East Bay Plain Subbasin Groundwater Sustainability Plan (GSP) Periodic Evaluation and Amendment

General Stakeholders Meeting
September 14, 2026

Land Subsidence SMC Updates

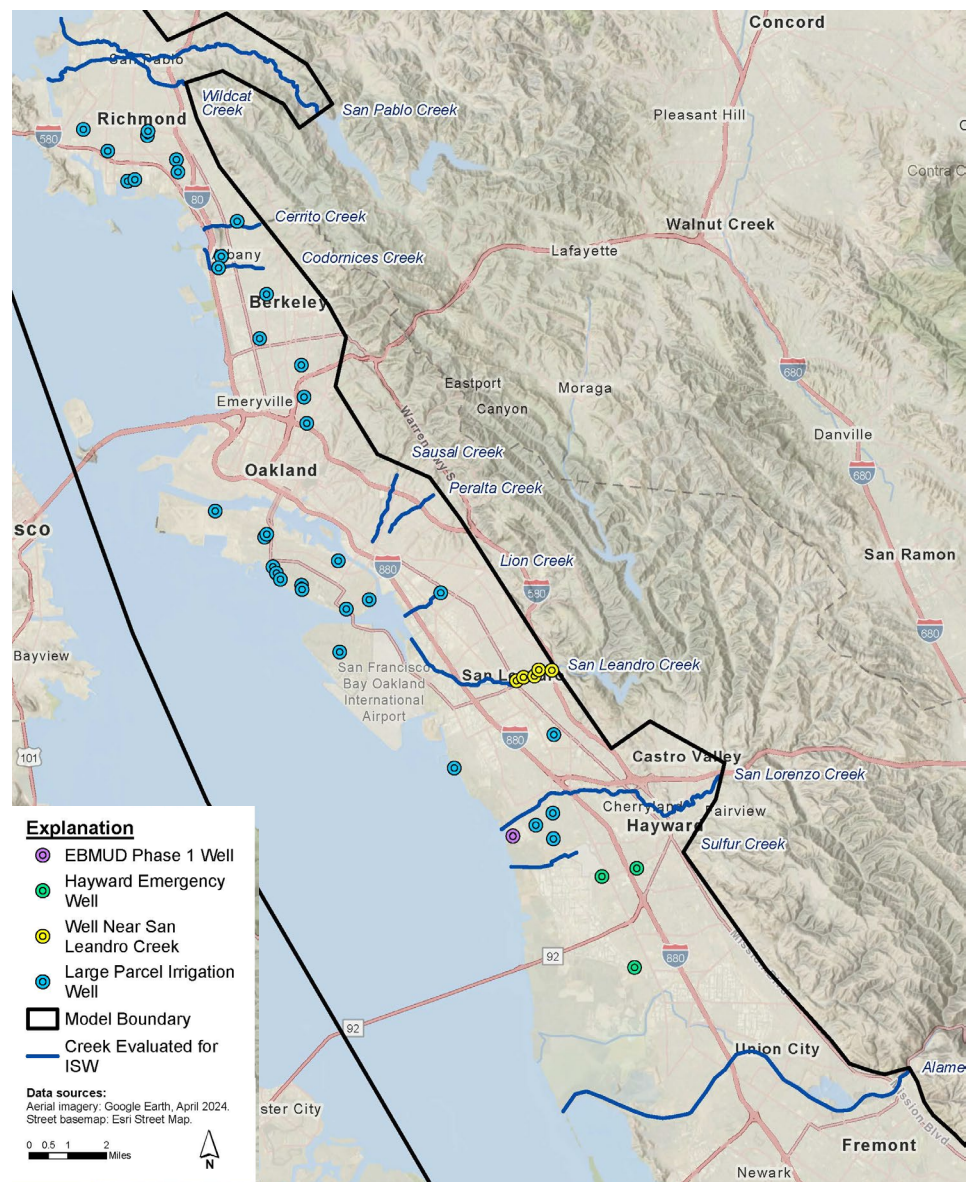
- Updated from using groundwater levels as a proxy to using vertical displacement estimates derived from Interferometric Synthetic Aperture Radar (InSAR) data provided by DWR

Minimum Threshold	Measurable Objective	Undesirable Result
Current conditions of no long-term subsidence and set at 0.1 foot* of annual subsidence	Current conditions of no long-term subsidence and set at 0.1 foot* of annual subsidence	25% or more RMS sites below MT for two consecutive years
